MONTICELLO NUCLEAR GENERATING PLANT
Docket No. 50-263 License No. DPR-22

Supplement No. 1 to License Amendment Request
Dated September 2, 1977

RESPONSE TO NOVEMBER 2, 1977 REQUEST FOR ADDITIONAL INFORMATION
MONTICELLO NUCLEAR GENERATING STATION
CONTAINMENT LEAK TEST DURATION

FIGURE 8-1

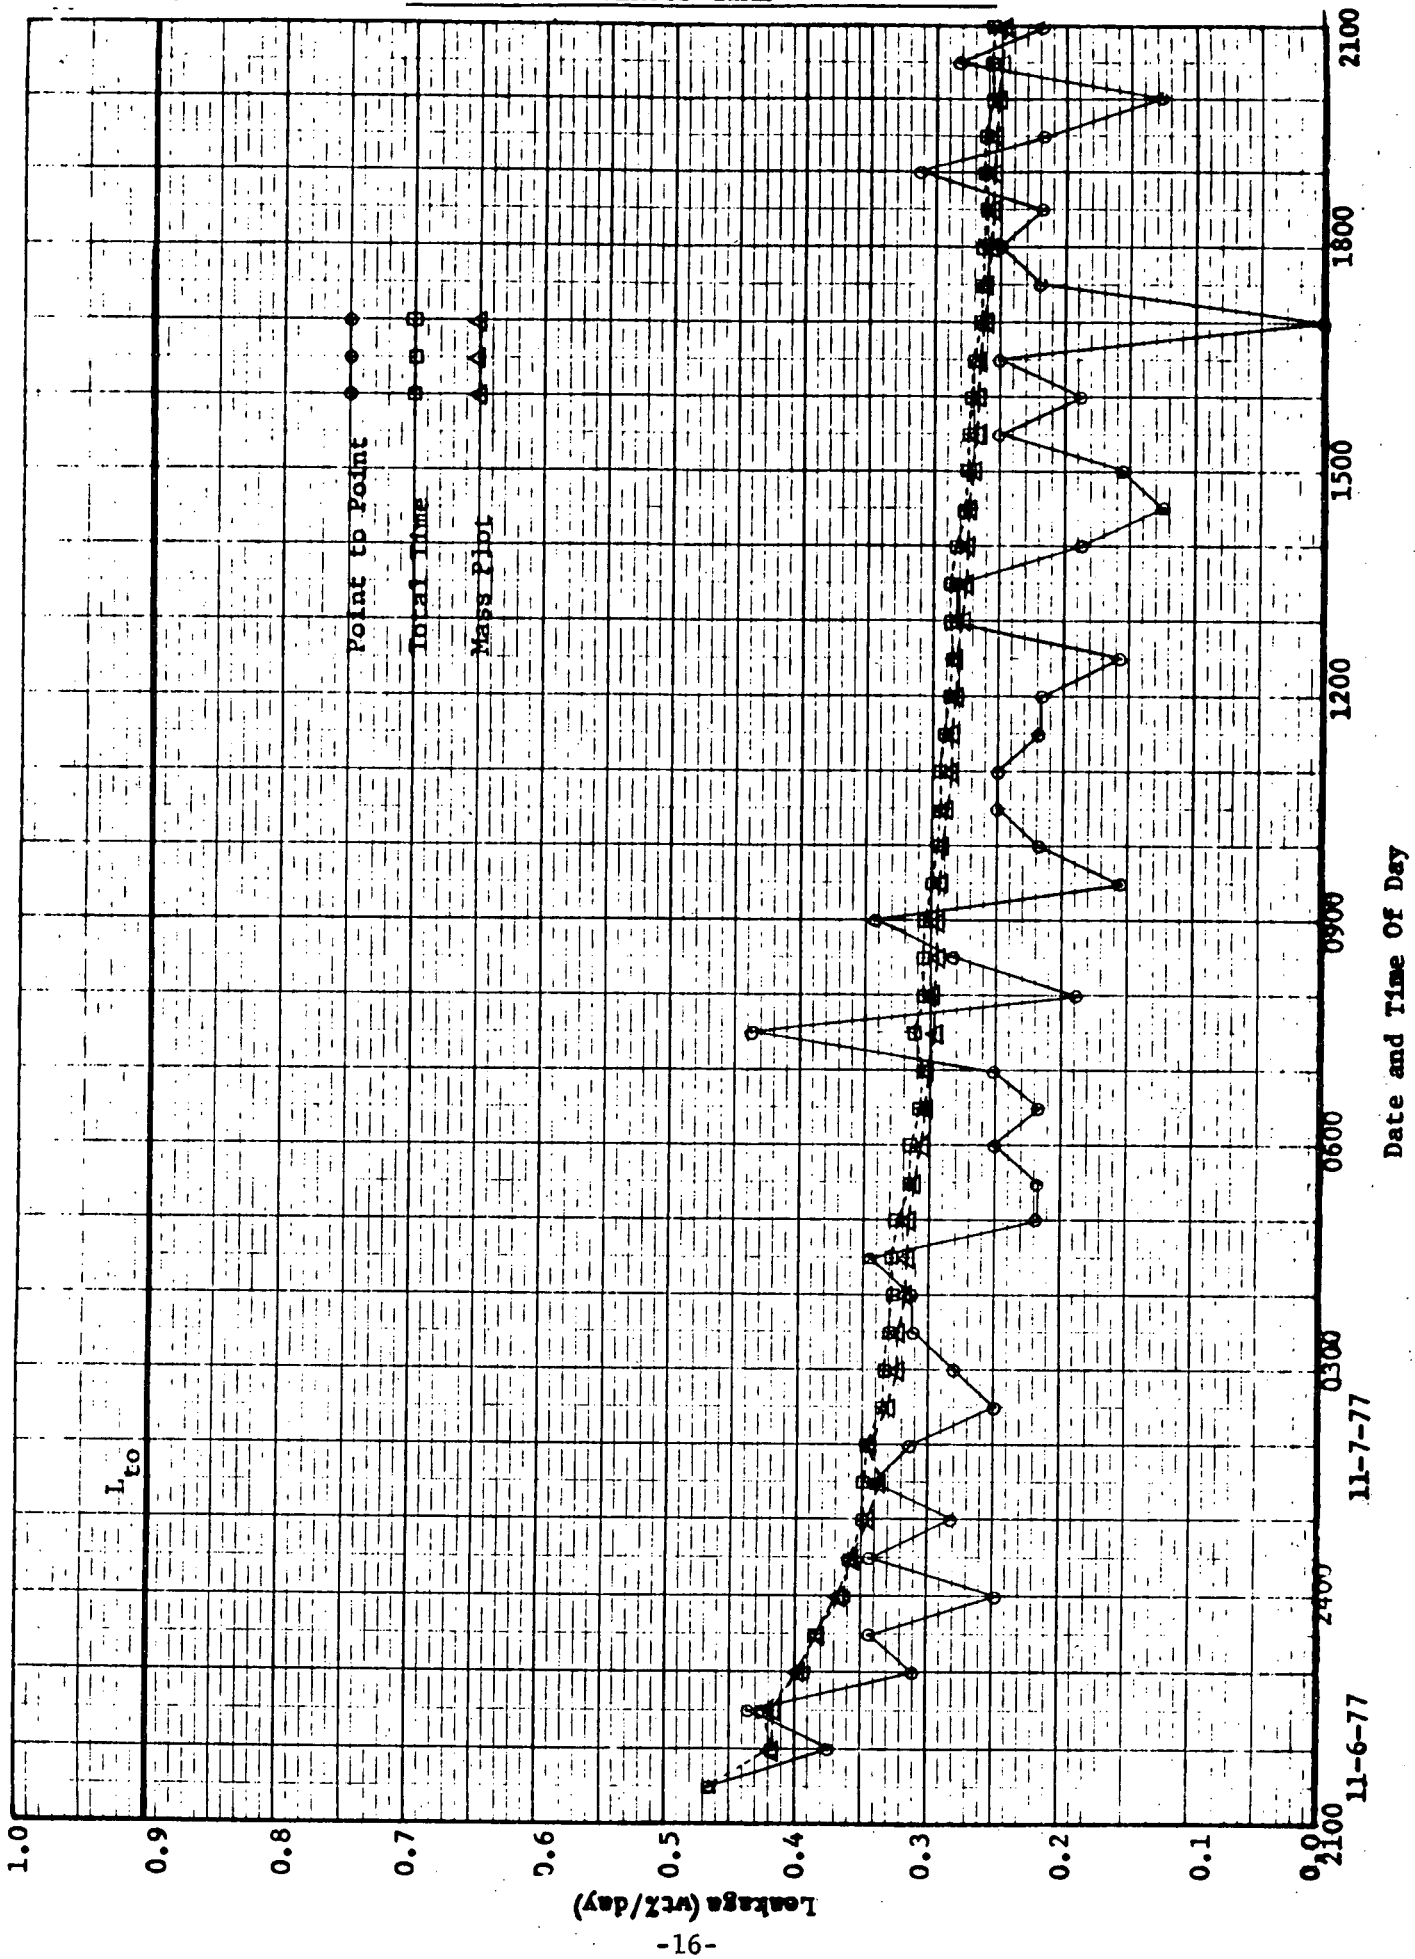
8. Previous testing experience has shown that there are a number of effects which become more pronounced as the CILRT duration decreases. In many cases, these effects are not adequately reflected in the confidence limits of the CILRT results. Demonstrate that the proposed minimum test duration in conjunction with the proposed testing procedure will adequately reflect each of the following effects:

d) diurnal effects relating to variations in the temperature of containment cooling water.

The effect of ingassing and outgassing is evident in plots of containment leakage rate versus time. As shown in the plot for the 1977 Monticello CILRT, ingassing generally results in a higher leak rate during the initial phases of the test and outgassing results in a lower leak rate during the final phases of the test. (Figure 8-1). Terminating the test following eight hours of data collection would result in a more conservative leakage rate measurement than the measurement obtained after 24 hours of testing.

We have been unable to detect any diurnal variation in containment leak rate versus time. Refer, for example, to Figure 8-1 which shows no dependence on time of day. Plots of all Monticello CILRT results may be found in References (3) through (7).
